We deeply appreciate the time and effort that the handling editor and the reviewers have put into improving this manuscript. The following contains all comments and our responses. Changes can be seen in the tracked-changes document.

1 Editor's Comments

Bias correction of Simulated Historical Daily Streamflow at Ungauged Locations by Using Independently Estimated Flow-Duration Curves

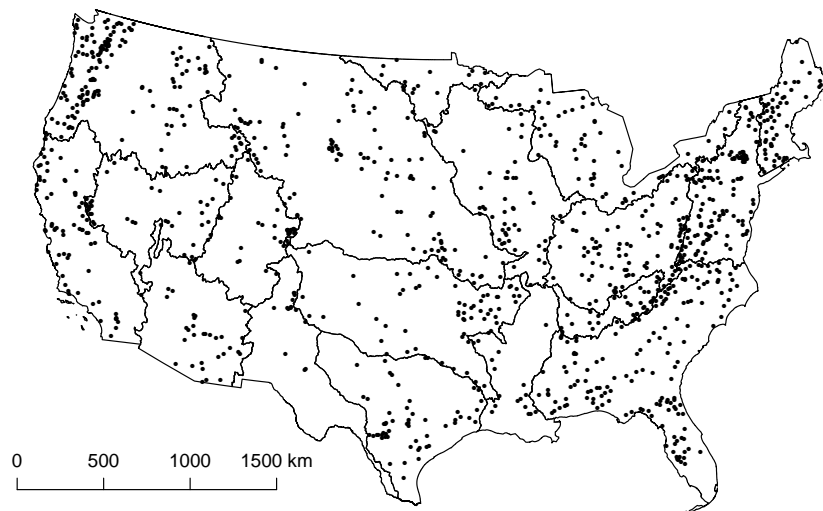
Reviewer Comment 2: Page 4, Line 1 – As the new version of Figure 1 is reporting only the selected streamgages, I would suggest to remove “and not-selected”.

Author Response 2: Revised as suggested.

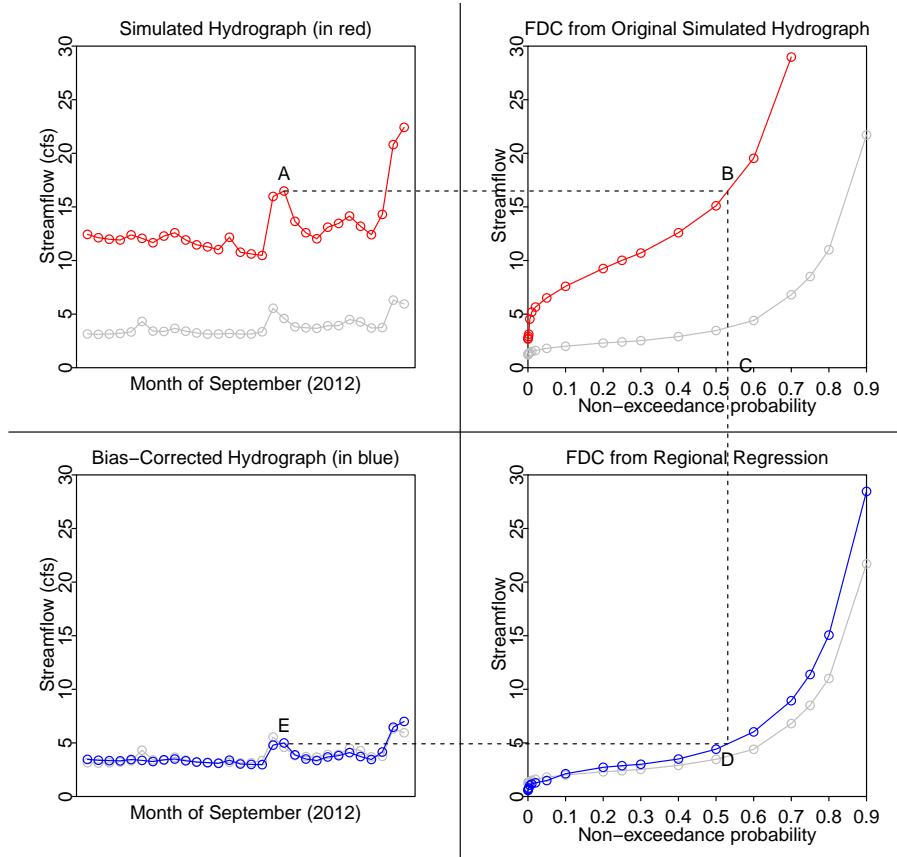
Reviewer Comment 12: Instead of commenting on the rest of the paper, I would like to strongly recommend that Authors should use hydrographs, flow duration curves etc. in presenting results. Explaining all the results using box plots is not very practical and it is hard to evaluate what Authors have presented in Section 3.

Author Response 12: In response to the previous round of reviews, this comment was addressed with addition of Figure 2 (revision). Presenting over 1000 different hydropgraphs and FDCs for independent evaluation is not an efficient use of space, though the accompanying data release allows interested users to explore this work further.

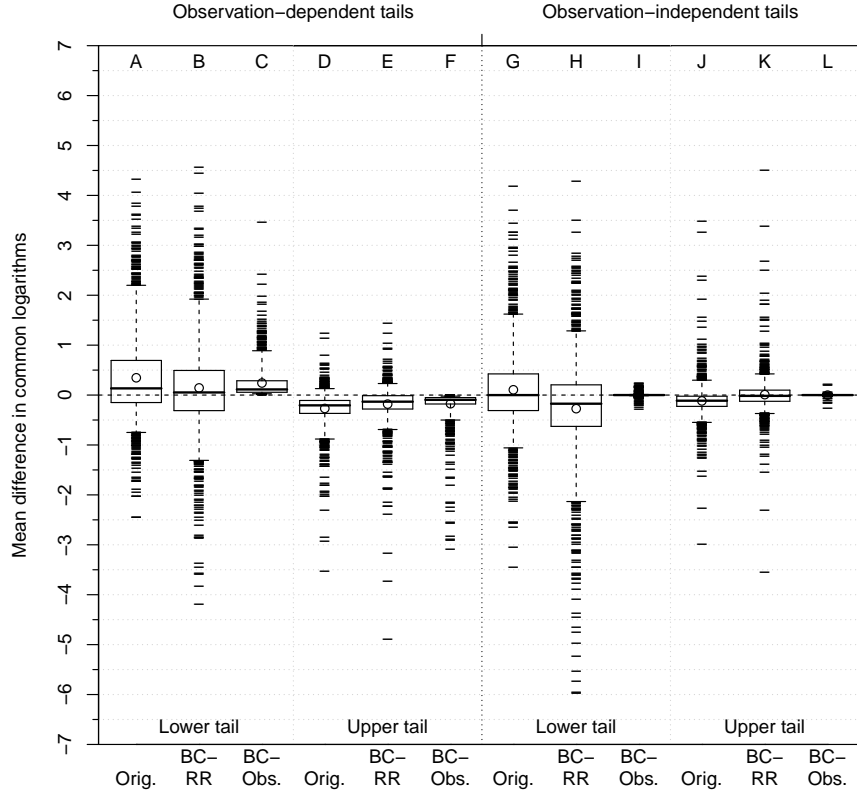
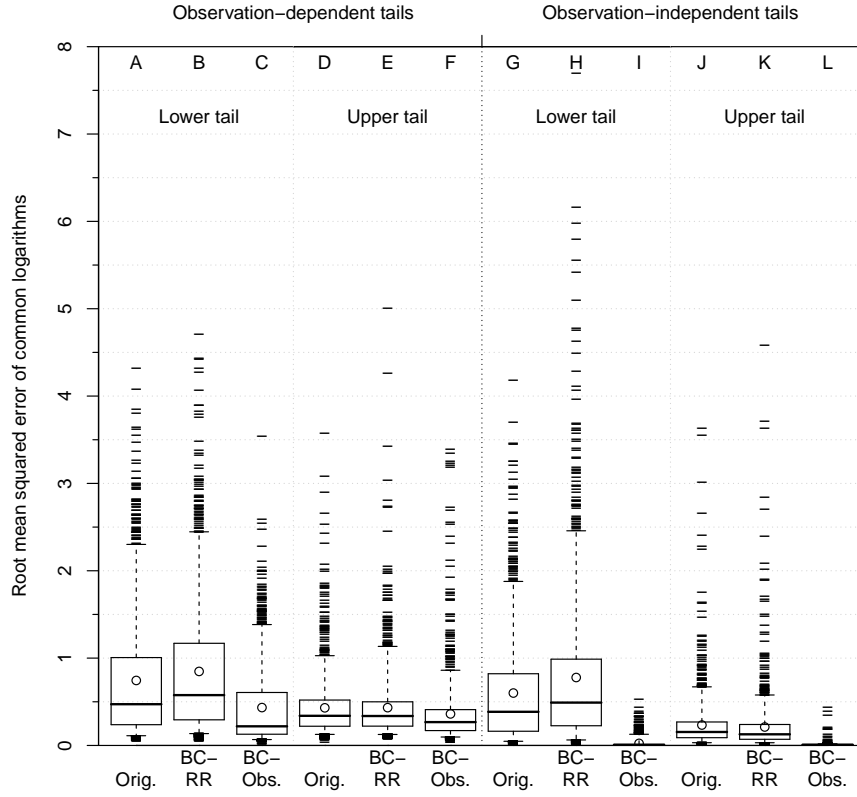
Reviewer Comment 11: P9/35 : You can conclude this. Figure 4 and 6 do not discuss the bias but the accuracy. Please reformulate.

Author Response 11: The first clause refers to Figure 5, while the second clause refers to Figure 6. We have added parenthetical references.

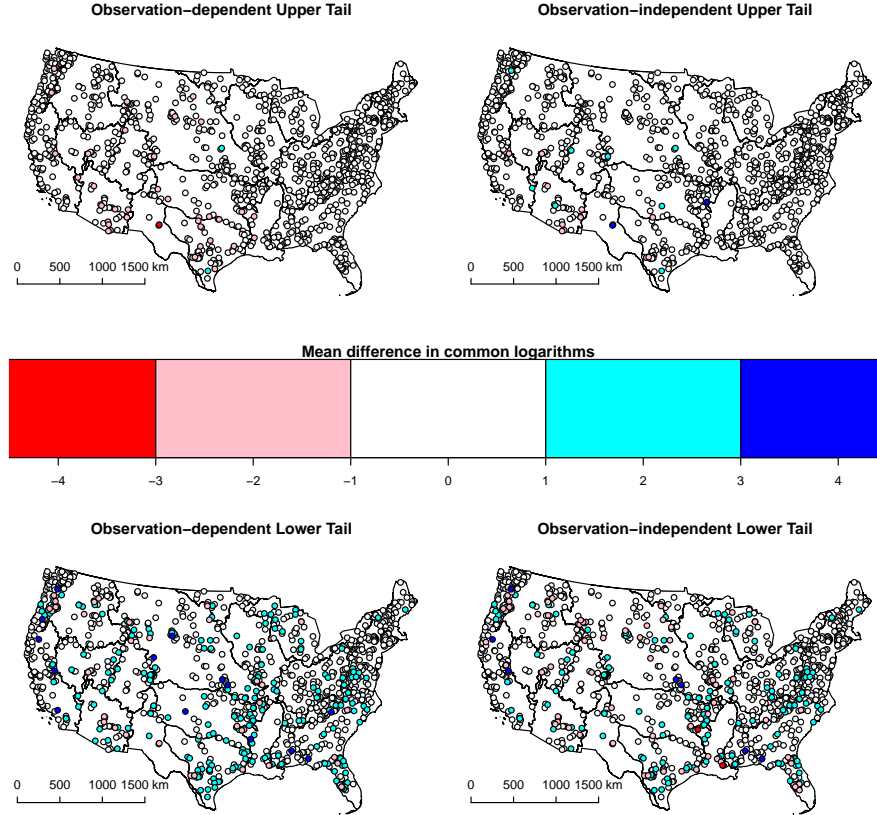
Reviewer Comment 10: P8/22 : Figure 7 is introduced but not commented > please comment.

15 **Author Response 10:** This figures is discussed later. We have added a parenthetical pointer to the later discussion.
